Stage 1 Road Safety Audit

Mixed Use Development, Crown Square, Galway City

On behalf of **Crown Square Developments Ltd**

October 2018

2.3.1 Tuam Road Northern Kerb/footpath

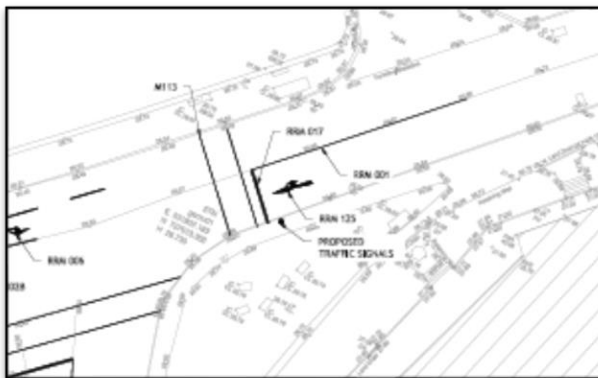
Problem: The existing kerb is laid to a low level and is damaged by over-running of vehicles. This is assumed to be as a result of right turning traffic being under-passed by straight ahead traffic.

Hazard: Impact with pedestrians on the footpath may result.

Recommendation: Move the existing road centre-line to the south in order to provide wider eastbound lanes on Tuam Road into this junction.

2.3.1	No	Yes	Existing defective kerblines are the responsibility of Galway City Council. Alternative road markings are proposed at this location to facilitate turning movements.	Yes

2.3.3 Joyce's Road Signals at Tuam Road Junction

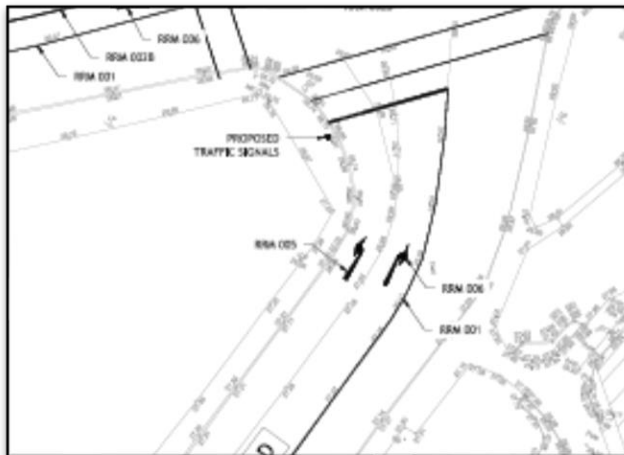
Problem: Northbound traffic on Joyce's Road will not have adequate forward visibility of the signal head.

Hazard: Overshoot into the junction may result

Recommendation: Redesign the junction to provide adequate forward visibility, ensuring inter-visibility between junction arms remains.

2.3.2	Yes	Yes		
2.3.3	Yes	Yes	Provide additional warning signs of junction ahead to prevent overshooting. A second primary head will be provided to the east of junction.	Yes

2.3.4 Tuam Road Junction – Pedestrian crossing of Joyce’s Road

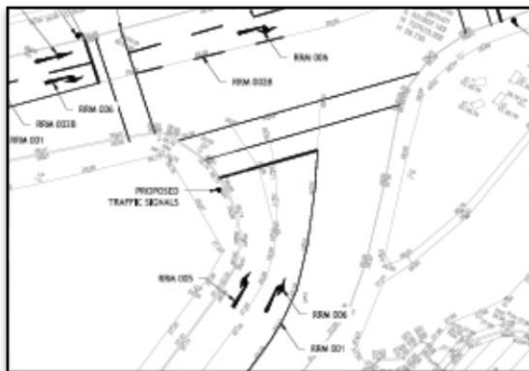
Problem: Pedestrians have a long road crossing to negotiate on the Joyce’s Road arm of the crossing.

Hazard: Frail or infirm users may have difficulty in completing the crossing in the ‘green man’ phase of the crossing. These users are at risk of vehicle impact.

Recommendation: Undertake vehicle swept path analysis in attempt to tighten up this arm.

2.3.4	Yes	No	Autotrack analysis has been undertaken and the radii and stop	Yes

TO BE COMPLETED BY DESIGNER				TO BE COMPLETED BY AUDIT TEAM LEADER
Paragraph No. in Safety Audit Report	Problem accepted (Yes/No)	Recommended measure accepted (Yes/No)	Describe alternative measure(s). Give reasons for not accepting recommended measure. Only complete if recommended measure is not accepted.	Alternative measures or reasons accepted by Auditors (Yes/No)
			lines are in appropriate locations to preclude vehicles entering oncoming traffic lanes.

2.3.5 Tuam Road Junction – Pedestrian Crossing of Joyce’s Road

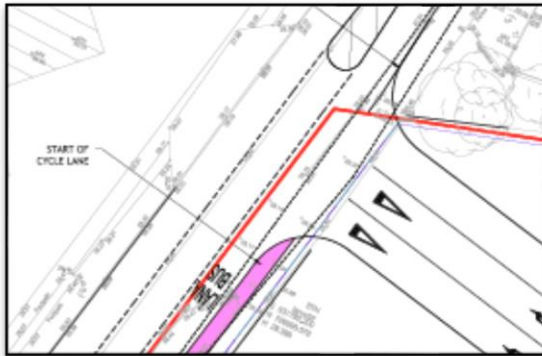
Problem: Pedestrians crossing southwest to northeast will have limited visibility of approaching traffic.

Hazard: Pedestrians who ignore the Red Man and enter the crossing are at risk if being struck by Joyce’s Road traffic who are shown a green light. This is considered a particular problem during off peak dark hours when pedestrians wrongly believe no traffic is approaching the junction.

Recommendation: Provide visibility for pedestrians.

2.3.5	Yes	Yes	Provide additional warning signs for pedestrians to reinforce vigilance of oncoming traffic. The client will attempt obtaining the permission of the landowner to remove the vegetation inside the boundary fence to provide visibility.	Yes

2.3.7 Drop-off point on Joyce's Road

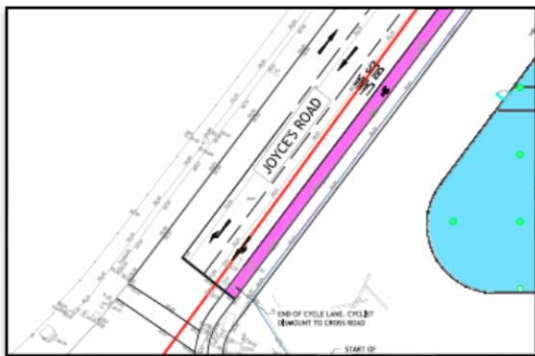
Problem: The drop off point on Joyce's Road is wide with shallow tapers.

Hazard: Multiple vehicles may stack in the drop off bay and queue out into the cycle lane and/or multiple vehicles may attempt to exit the bay at the same time. Impact with cyclists may result.

Recommendation: Provide suitable road markings to provide guidance in use to patrons.

2.3.9 Cyclist provision on Joyce’s Road approach to Monivea Road Junction

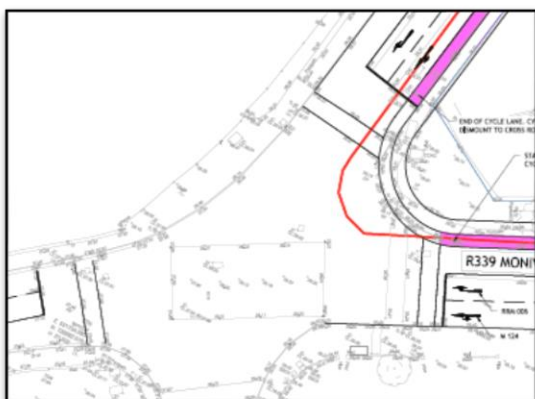
Problem: Cyclists wishing to turn right at this junction without dismounting are not catered for.

Hazard: Cyclists may stay on the cycle lane up to the junction and turn right across left turning traffic. Impact may result.

Recommendation: Provide suitable facilities to enable on-road cyclists to turn right safely at this junction. The design team should note Galway City Council have provided ‘Box turns’ elsewhere as detailed in the National Cycle Manual.

2.3.6	Yes	Yes		
2.3.7	Yes	Yes		
2.3.8	No	Yes	Drawings already updated	
2.3.9	Yes	Yes	Drawings already updated.	
2.3.10	No	No	Provide additional signs and or road markings to reinforce to drivers the need to be in the correct lane.	Yes

2.3.10 Westbound Monivea Road Approach to Signalised Junction

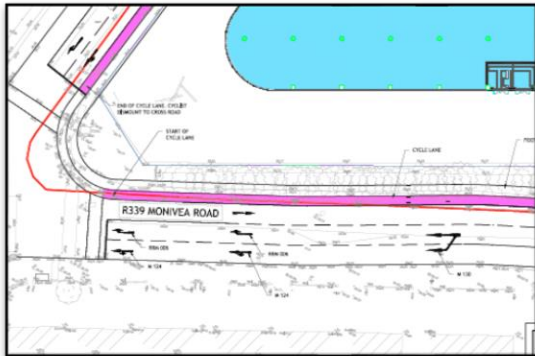
Problem: Some 'straight ahead' traffic may arrive at the junction in the offside lane, with others obeying the road markings and occupying the near side lane.

Hazard: Side impact may occur as both vehicles attempt to exit the junction into the single lane.

Recommendation: Widen the exit of the junction to permit dual lane exit.

2.3.13 Drop-off Point on Monivea Road

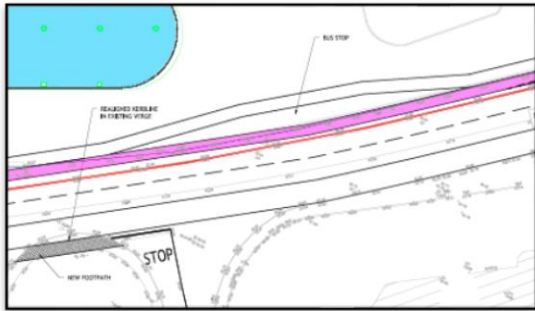
Problem: The drop off point on Monivea Road is wide with shallow tapers.

Hazard: Multiple vehicles may stack in the drop off bay and queue out into the cycle lane and/or multiple vehicles may attempt to exit the bay at the same time. Impact with cyclists may result.

Recommendation: Provide suitable road markings to provide guidance in use to patrons.

2.3.15 Termination of Cycle Lane at Development Junction

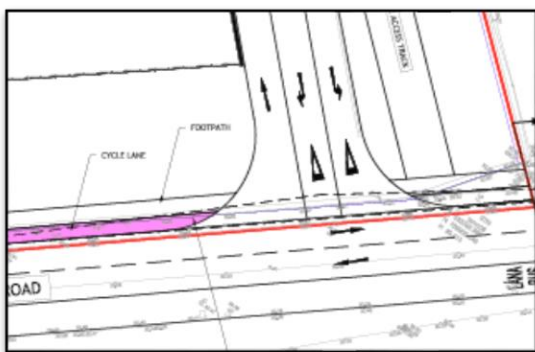
Problem: Cyclists departing the cycle lane will be close to the nearside road edge.

Hazard: Vehicles exiting the development may proceed to the edge of the main carriageway prior to yielding. Impact with cyclists may result.

Recommendation: Extend the cycle lane to the far side of the development junction.

2.3.15	Yes	Yes		
2.3.16	Yes	Yes		
2.3.17	Yes	Yes

2.3.16 Fire Tender Access of Monivea Road

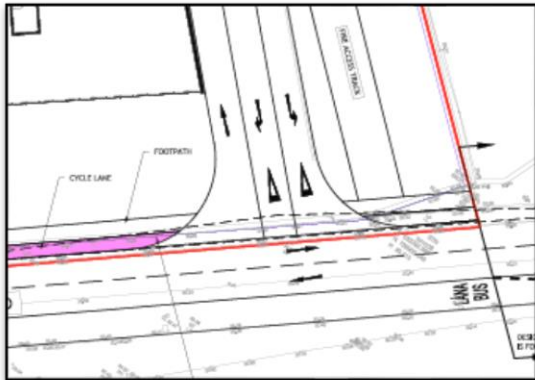
Problem: No details of the interface of the fire tender access with the public road have been shown.

Hazard: Errant public access to the lane may result.

Recommendation: The design team should ensure only the fire tender can access this lane.

2.3.18 Greenway Development to South of Monivea Road

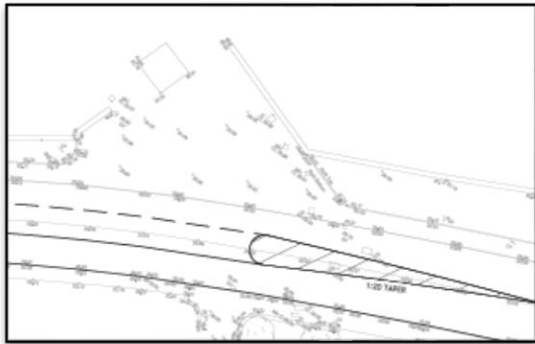
Problem: No details are given for road junctions to the ongoing Greenway Development to the opposite side of Monivea Road.

Hazard: Conflicting traffic movements may result.

Recommendation: The Design Team should ensure these proposals do not interfere with the Greenway Development.
